Supporting Statement for Planning Application Ref 71000

Erection of 17 no. small light industrial units with associated servicing
and car parking

Eton Business Park, Eton Hill Road, Radcliffe

May 2025

Sheet Title
**Proposed Site Layout: Swept Path Analysis
- Large Van**

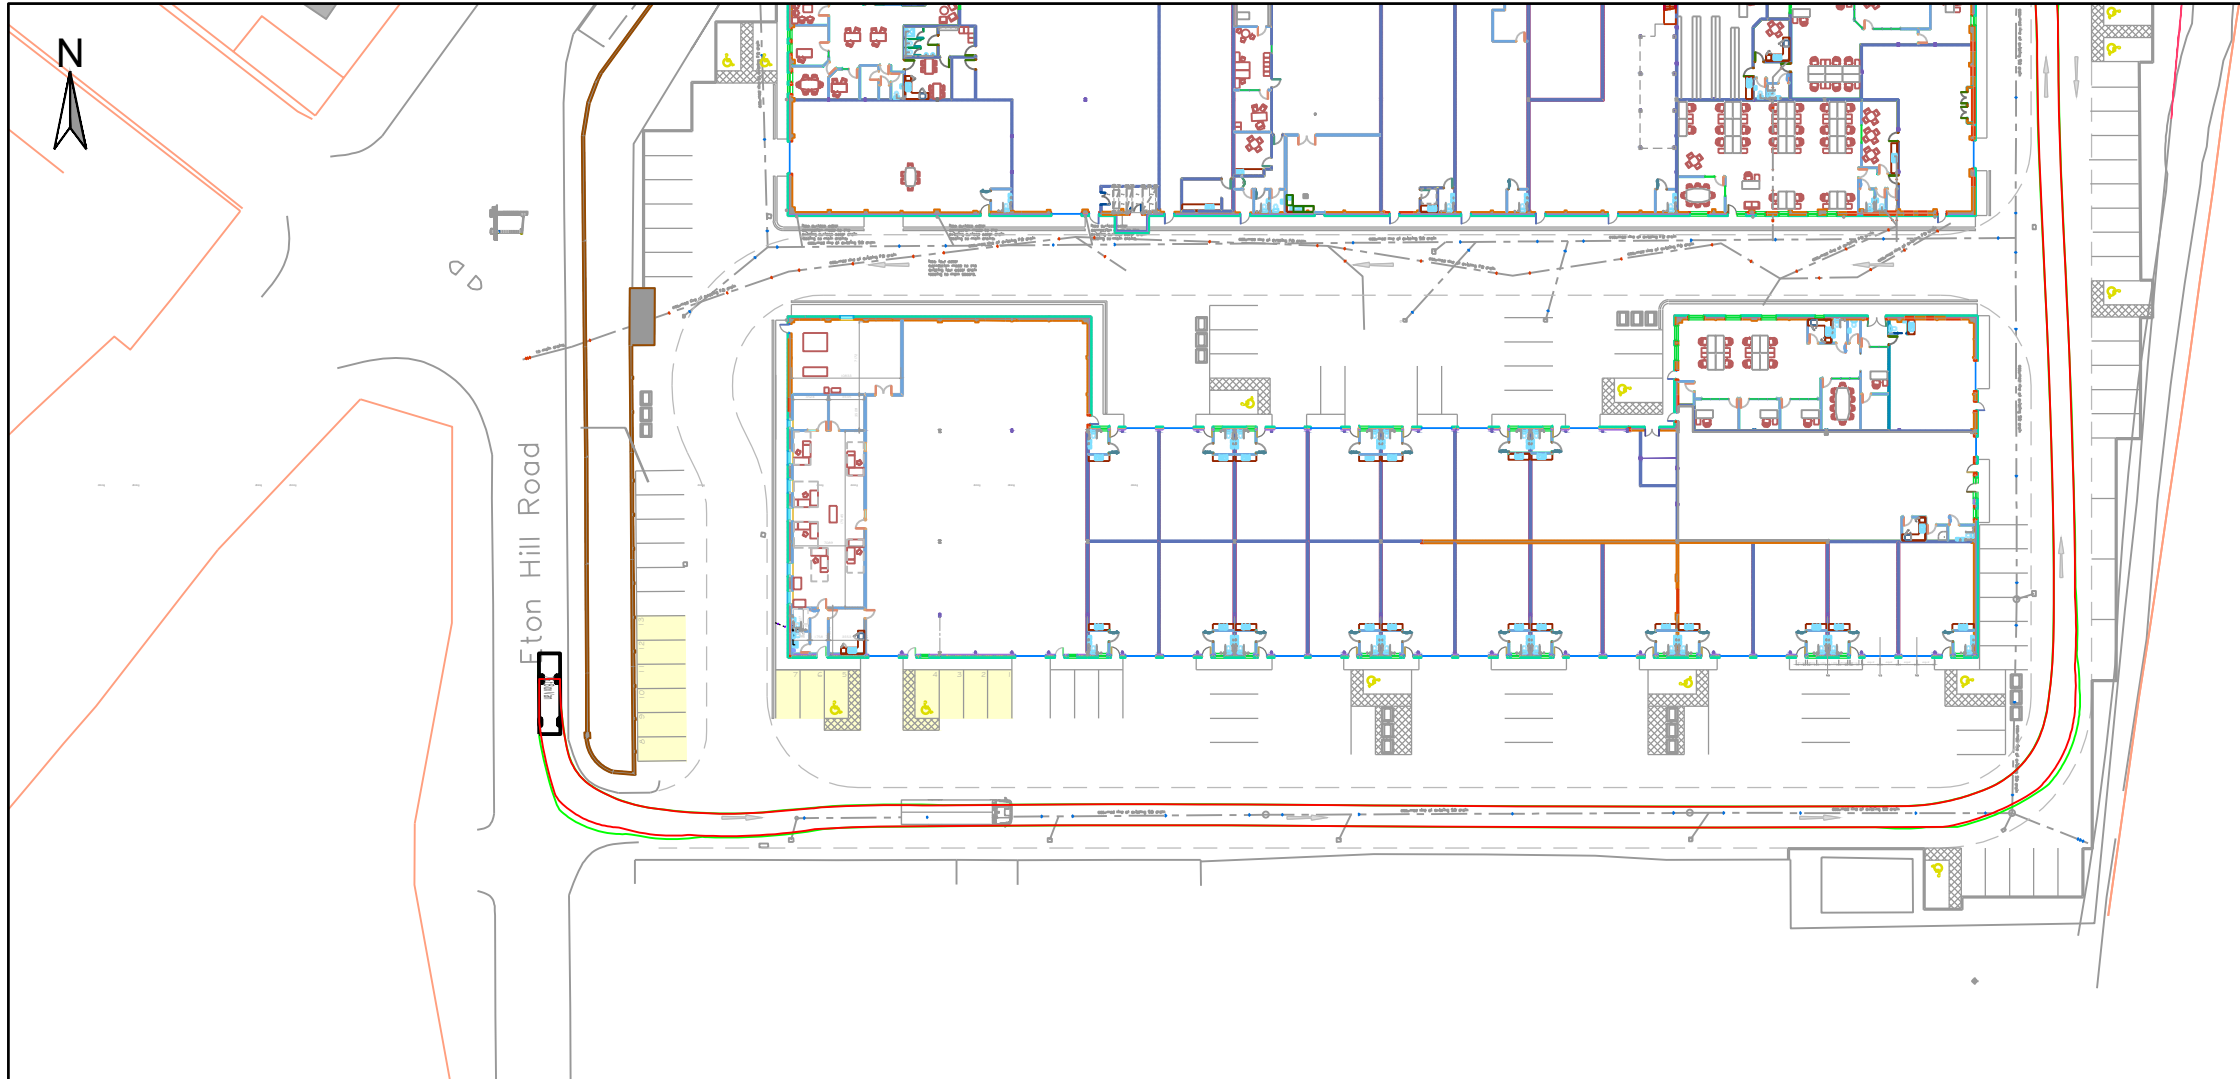
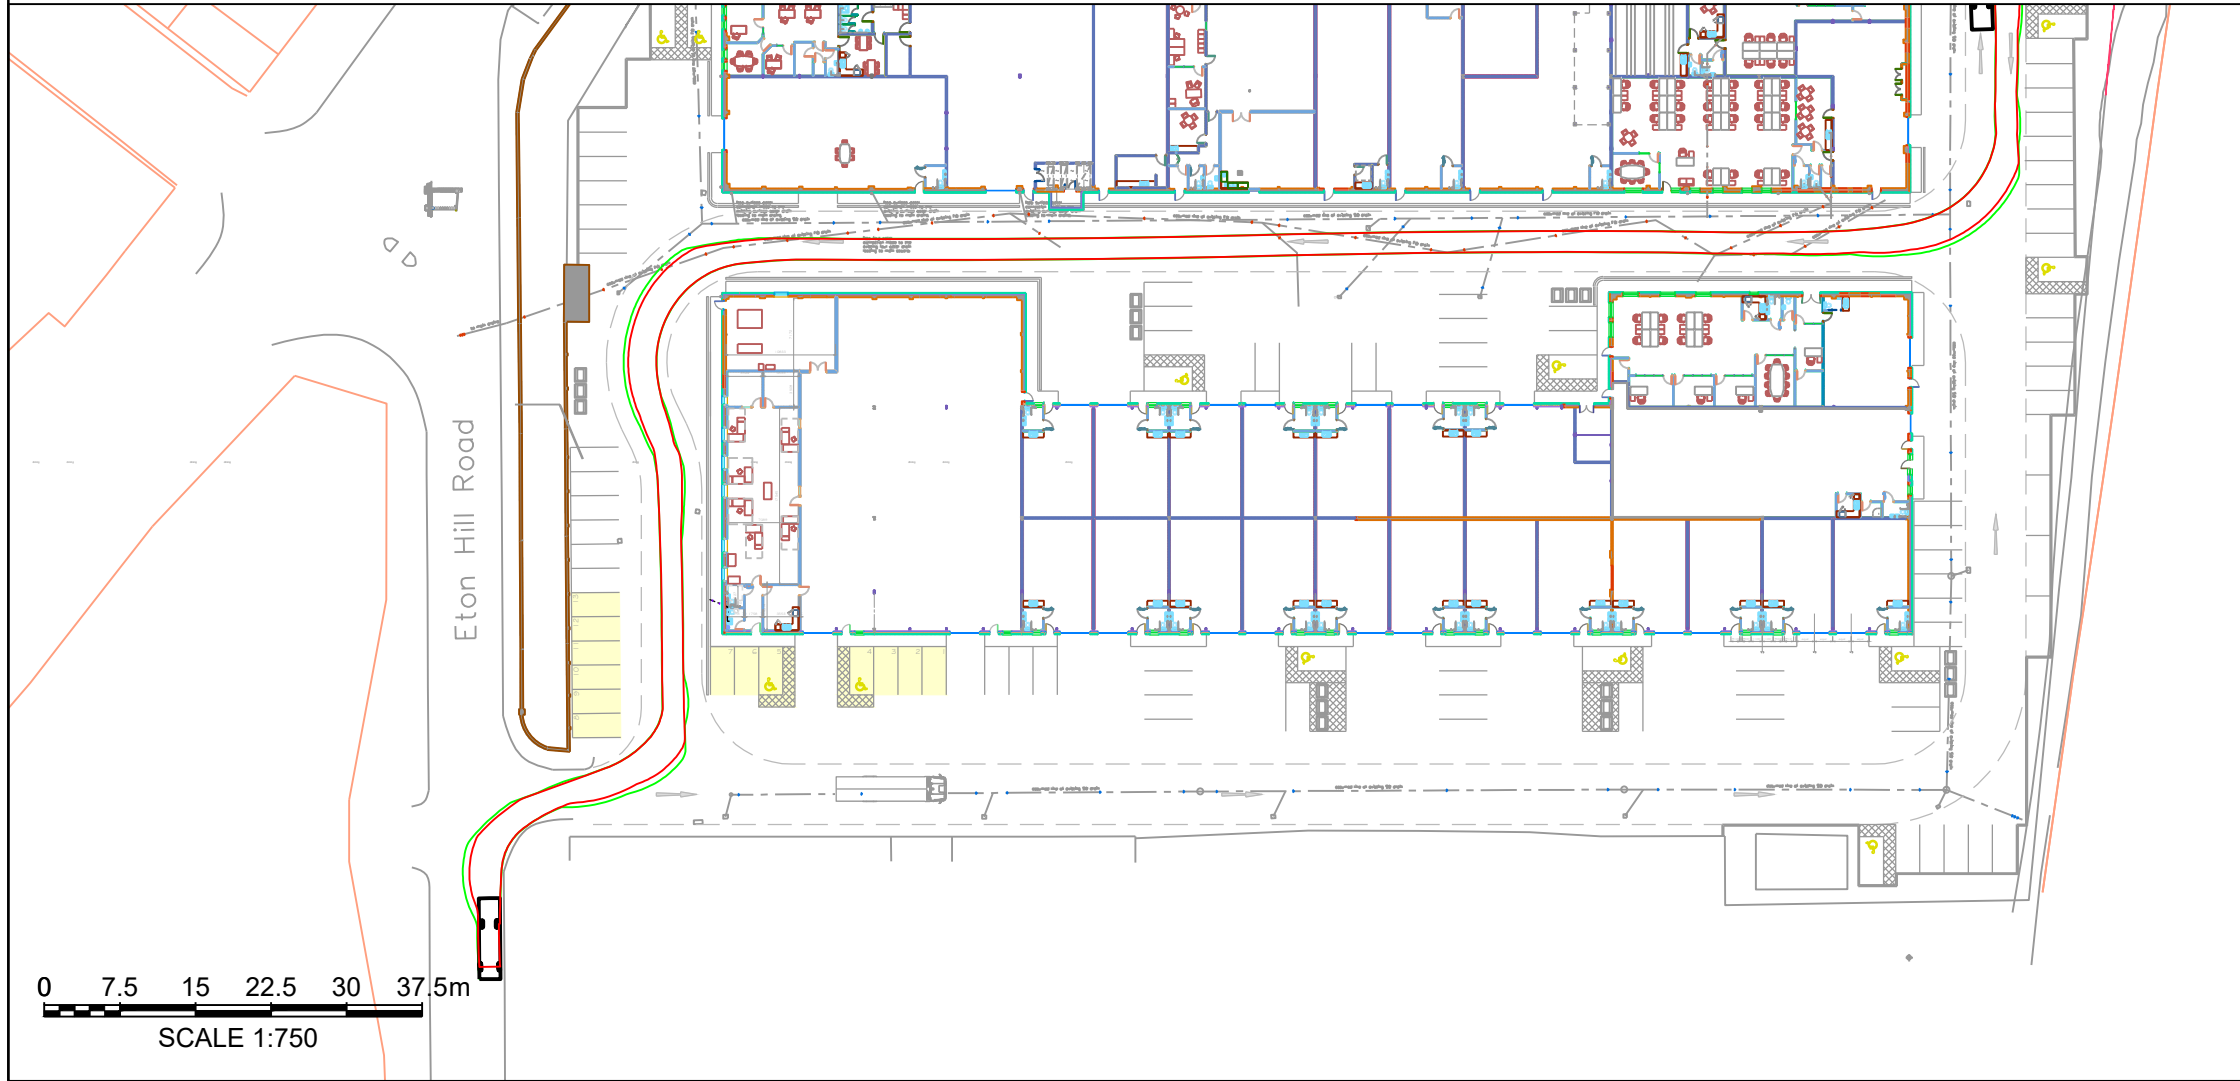
Swept path plans are contained within the TN appendices for a large box van to demonstrate that the largest intended service vehicle can enter and exit the site in forward gear, carrying out turning manoeuvres within the car park.

- 3.1.1 This section addresses the LHA comments relating to tracking for the proposed site layout.
- 3.1.2 The proposed site layout contained in **Appendix 3**. The site layout has changed due to the provision of additional parking spaces.
- 3.1.3 Given the comments from the LHA and revised site layout, tracking has been carried out with:
- A large box van
 - A refuse vehicle
 - A fire appliance.
